# SERVICE BULLETIN

Service Bulletin No.: DAC1-92-02, Rev. 0

Title: Certification, United Kingdom Import Requirements

Figure 1 – VLA Label placement on the instrument panel

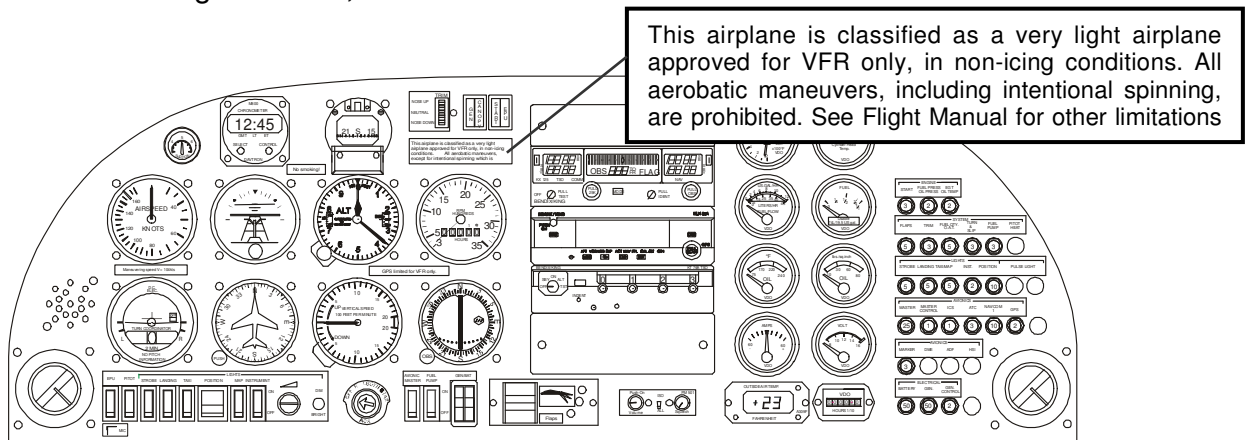
- 10.1 **Label** - Insure the VLA label (spinning prohibited) is correctly installed, as per the flight manual, document DA202-C1.
